**Amendments to the Drawings**

The attached four (4) sheets of drawings include changes to Figs. 1, 2, 6 and 11. These sheets replace the original sheets of drawings.

FIG. 2

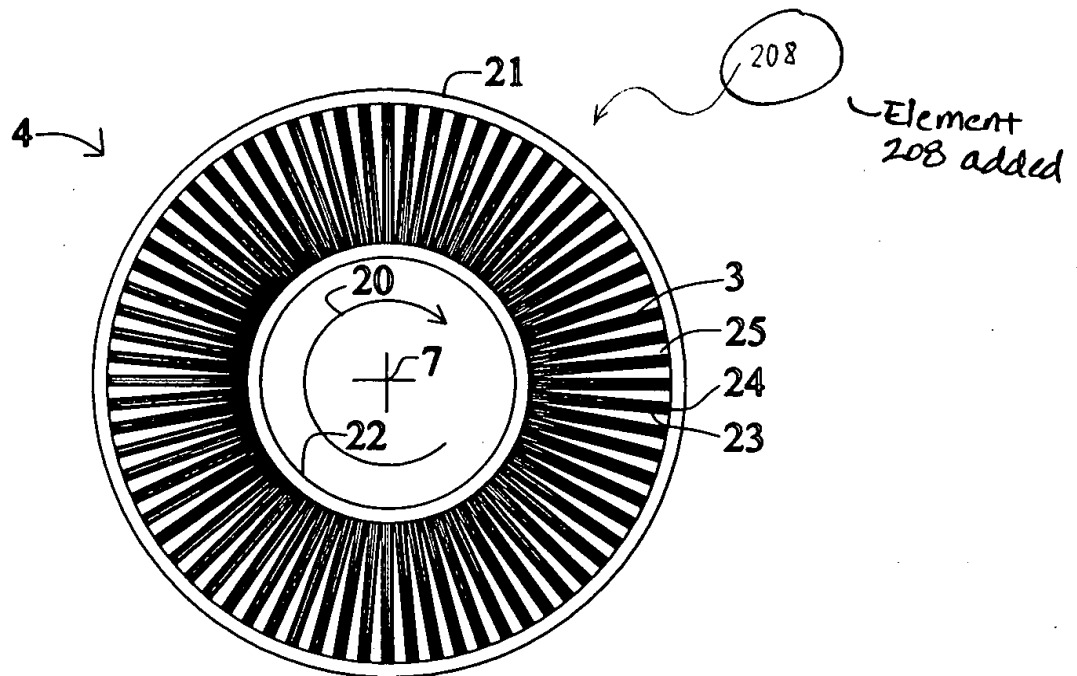
In Fig. 2, the adsorber wheel has been identified with the reference numeral "208."

FIG. 6

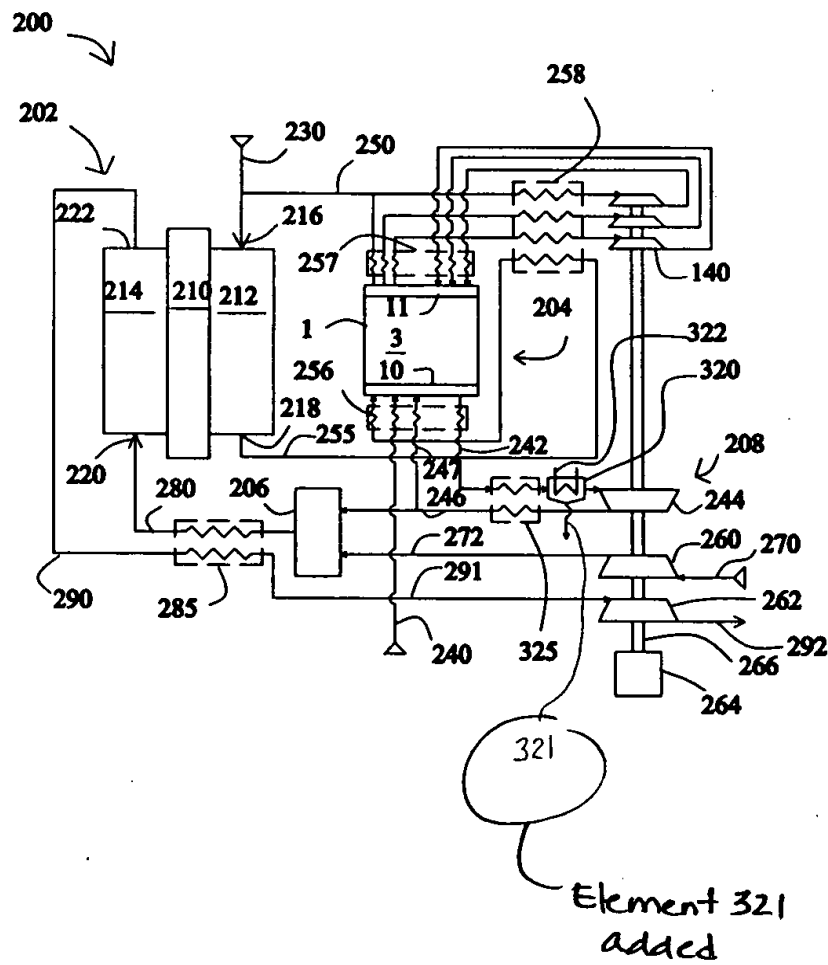
In Fig. 6, the drain has been identified with the reference numeral "321."
